**SUBJECT: Annual Report – Year 2 for the Abandoned Deactivation Furnace (SEAD-16) and the Active Deactivation Furnace (SEAD-17) Sites at Seneca Army Depot Activity; Contract FA8903-04-D-8675, Delivery Order 0031, CDRL A001G**

**Subject:** Annual Report - Year 2 for SEAD-16 and SEAD-17  
Seneca Army Depot  
Romulus, New York

**Subject:** Annual Report - Year 2 for SEAD-16 and SEAD-17

## **FINAL ANNUAL REPORT - YEAR 2**

**FIGURE 3**  
**SEAD-16**  
**SITE PLAN**

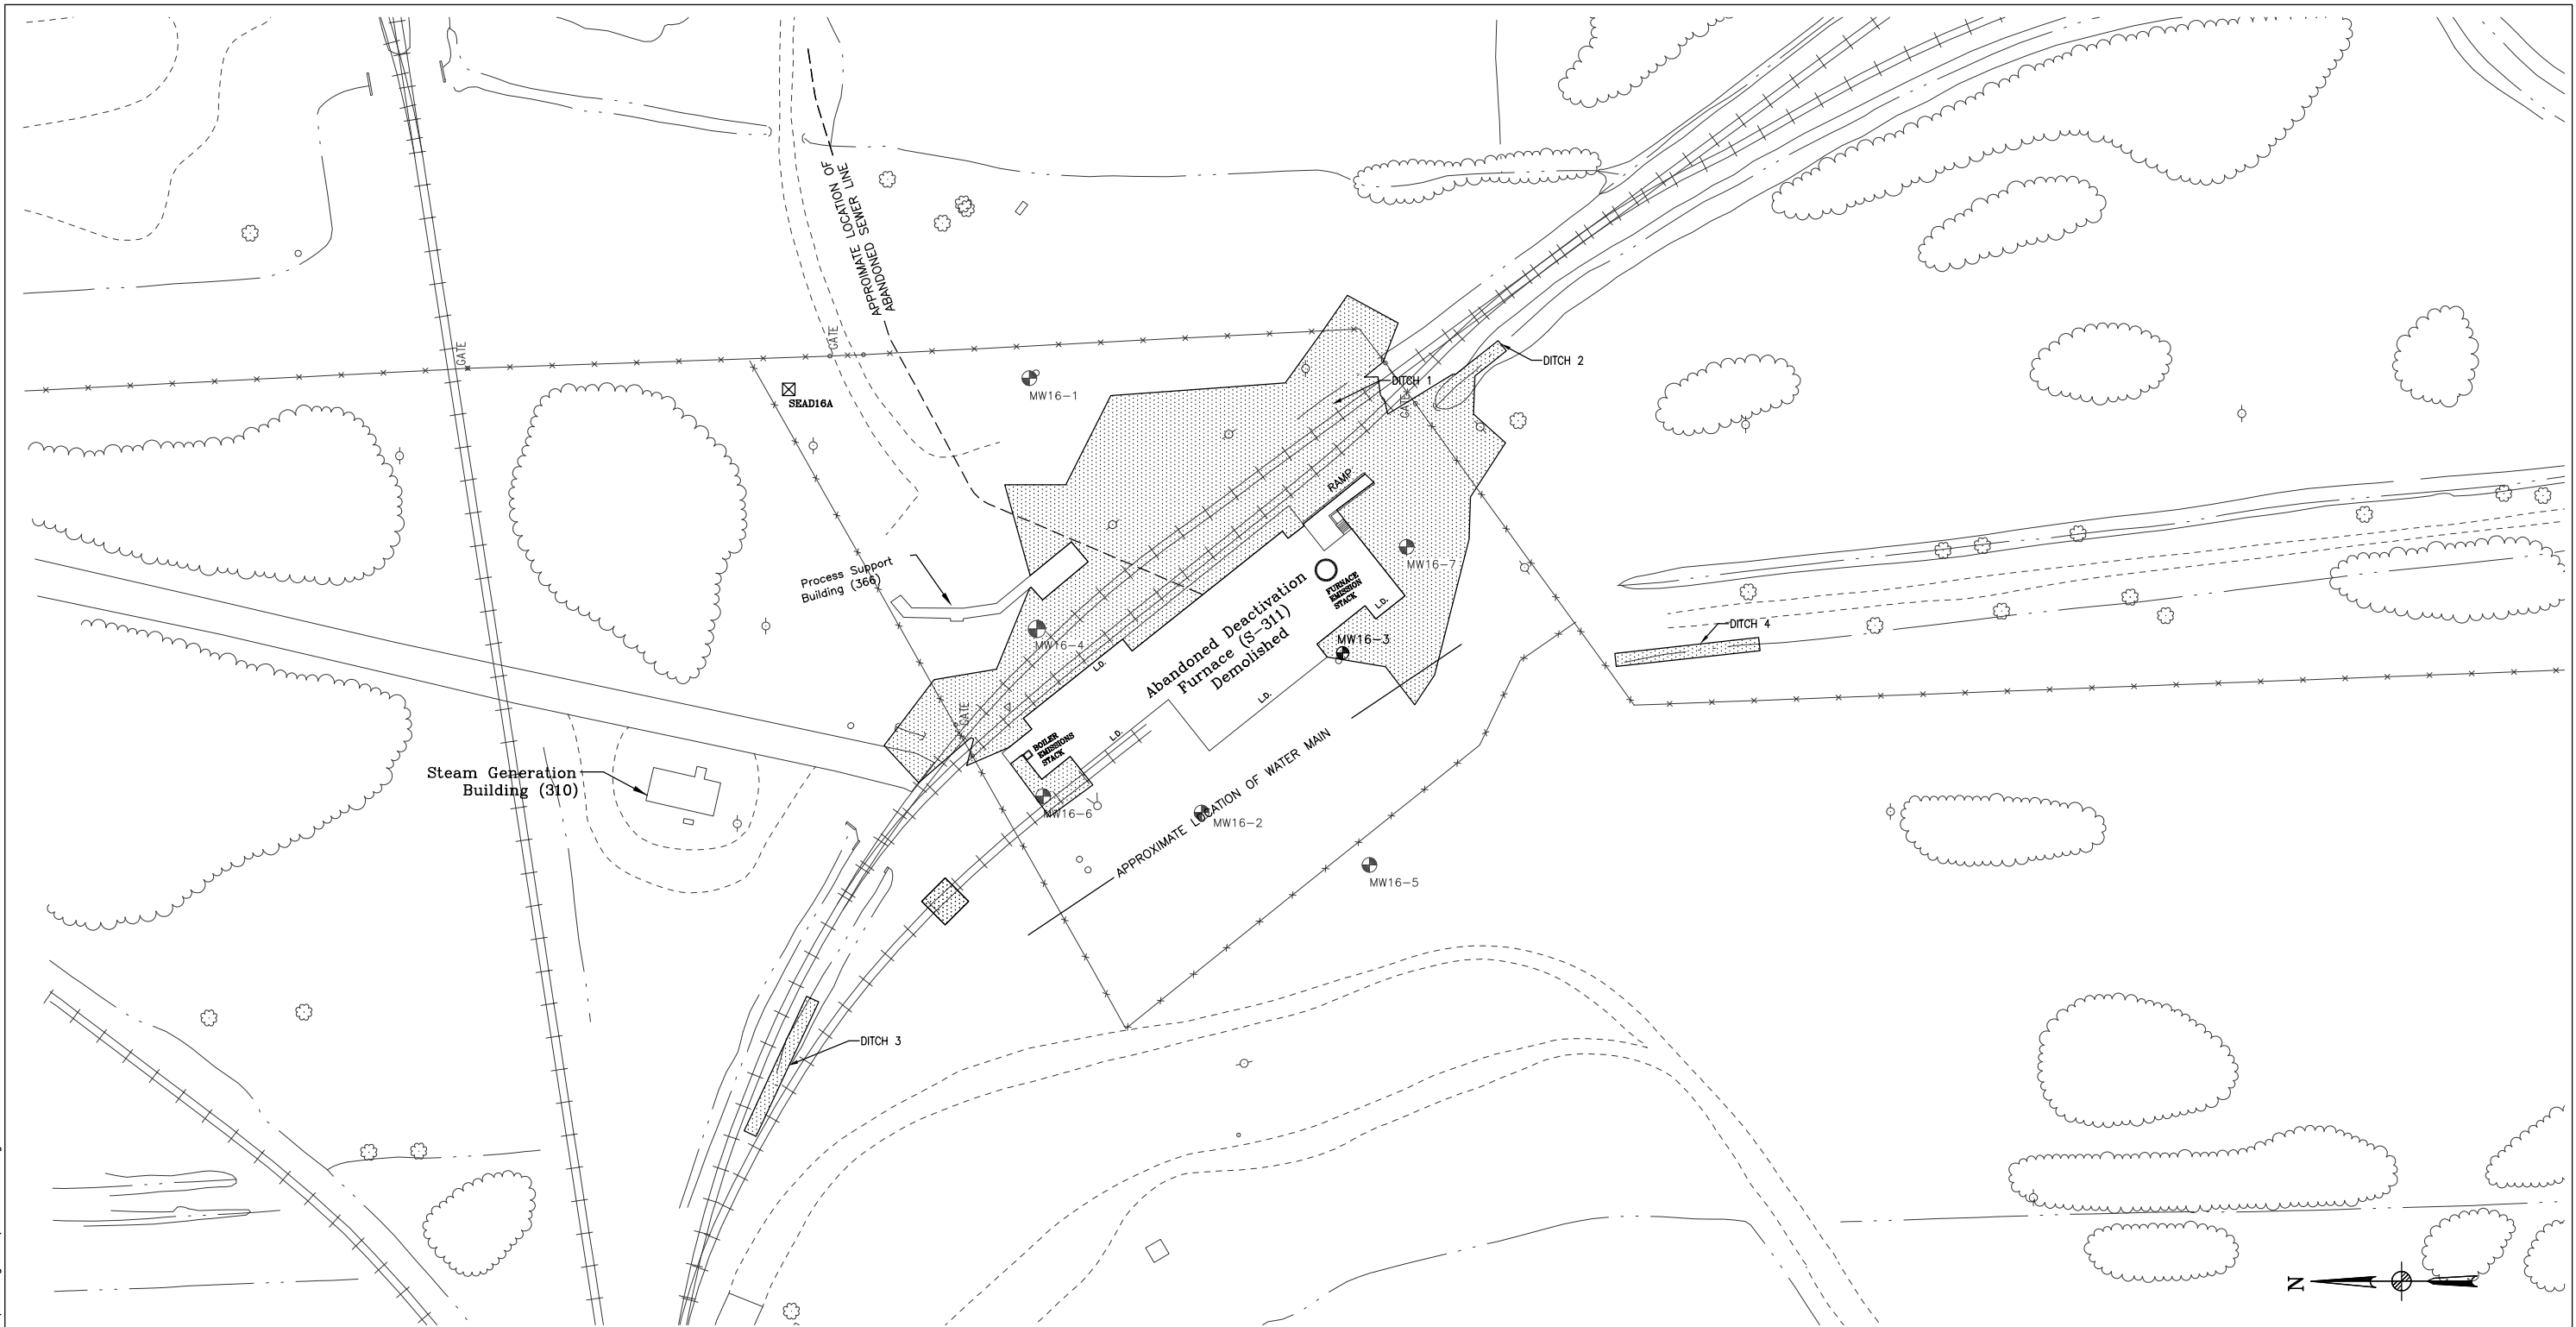
**Comment 3:** According to Section 3.2, Year 2 Groundwater Sampling, monitoring well MW16-3 was destroyed during the remedial action and was not sampled. No comment on the significance of the exclusion of this well has been provided in the Annual Report, and it is unclear whether a data gap now exists in the monitoring well network at SEAD-16. Provide a discussion in the Annual Report which addresses this issue. In addition, provide the former location of well MW16-3 on Figure 3, SEAD-16 Site Plan.

**Response 3:** Figure 3 was revised to include the location of former monitoring well MW16-3. Destruction of monitoring well MW16-3 does not present a data gap since there are monitoring wells located down gradient from the location of the former well.

**FIGURE 5  
SEAD-16 AND 17  
GROUNDWATER FLOW TREND**

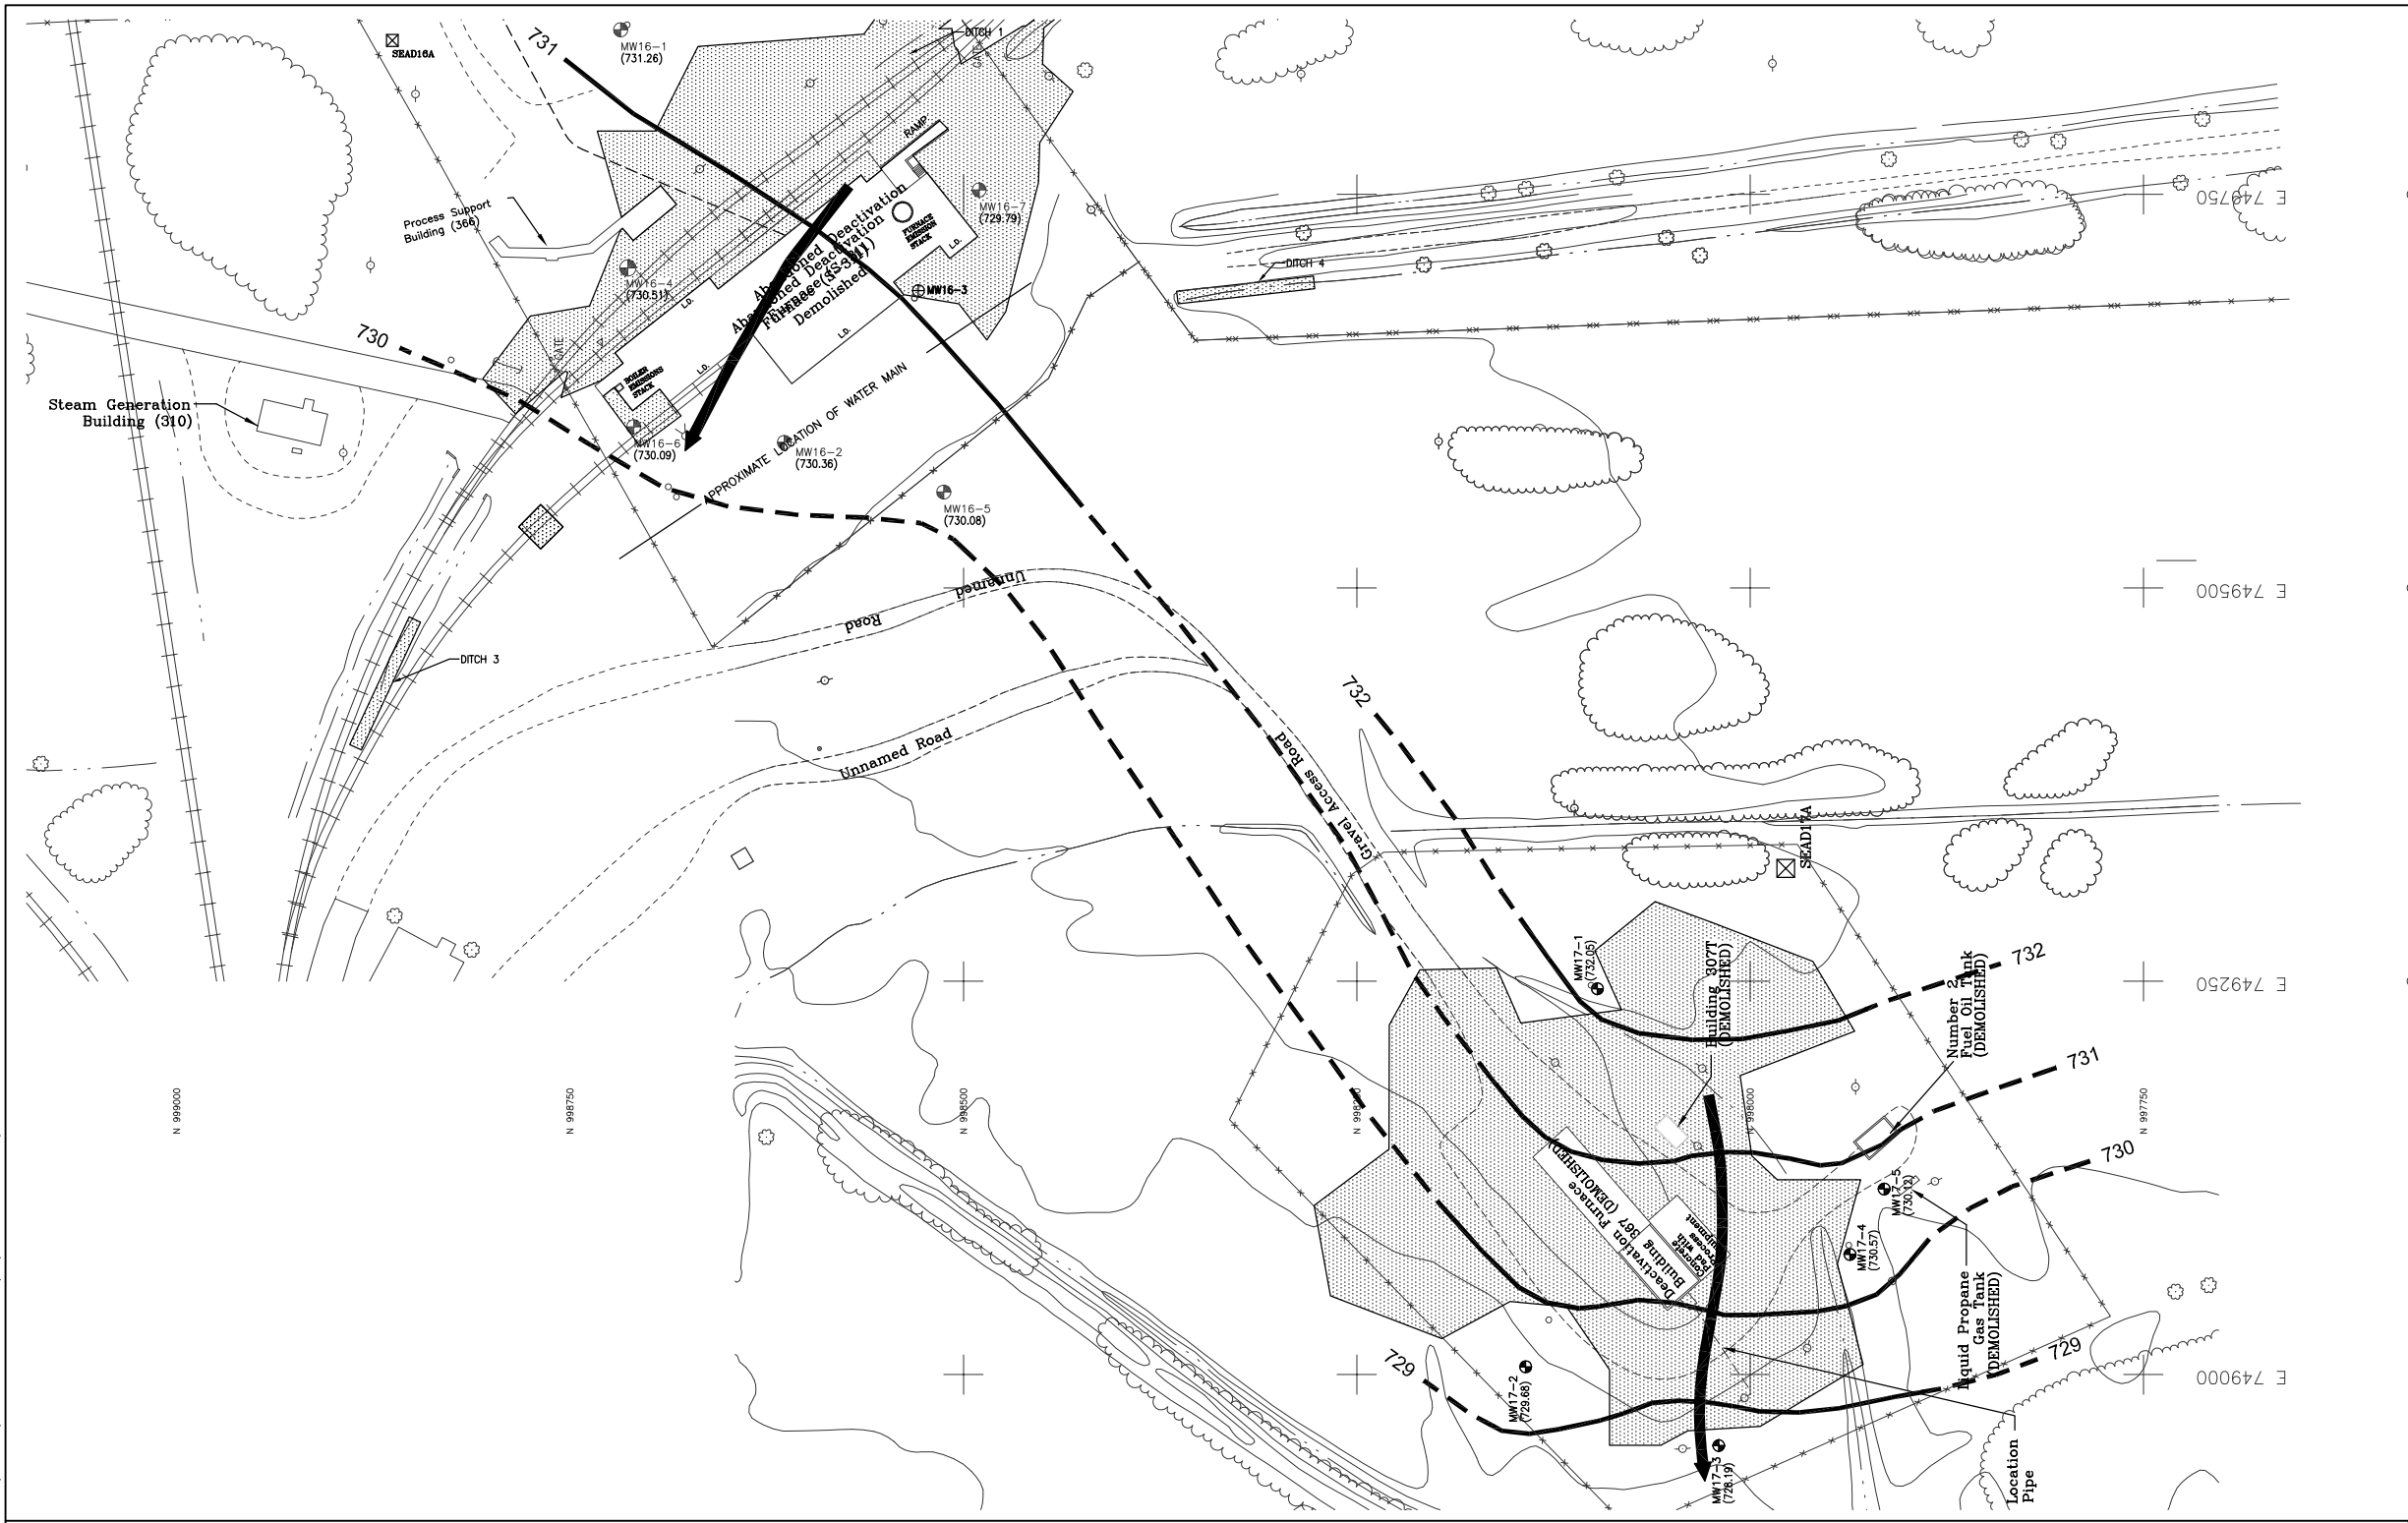
**Comment 7:** Groundwater elevation data for SEAD-16 and SEAD-17 are provided in Tables 1 and 2 of the Annual Report, but figures depicting groundwater flow direction have not been provided. As supporting documentation for the groundwater flow directions described in the text of the document, revise the Annual Report to include site figures which plot the groundwater elevation data and show the direction of groundwater flow.

**Comment 1: Section 3.5, Year 2 Groundwater Data Analysis for SEAD-17, Page 3-3.** As stated in this section, monitoring well MW17-3 is described as an upgradient well; however, based on review of the groundwater table elevation data provided and the fact that groundwater flow was cited to be in a general southwesterly direction, it appears that well MW17-3 is not upgradient of the deactivation furnace at SEAD-17. Revise the Annual Report to address this concern or provide a figure which depicts groundwater contours to support this conclusion.

**Response 7:** Figures that show the groundwater flow direction for SEAD-16 and SEAD-17 have been prepared and will be referenced in the report.

**Response 1:** The text will be revised to indicate that well MW17-3 is a down gradient monitoring well. The revised text is shown below.
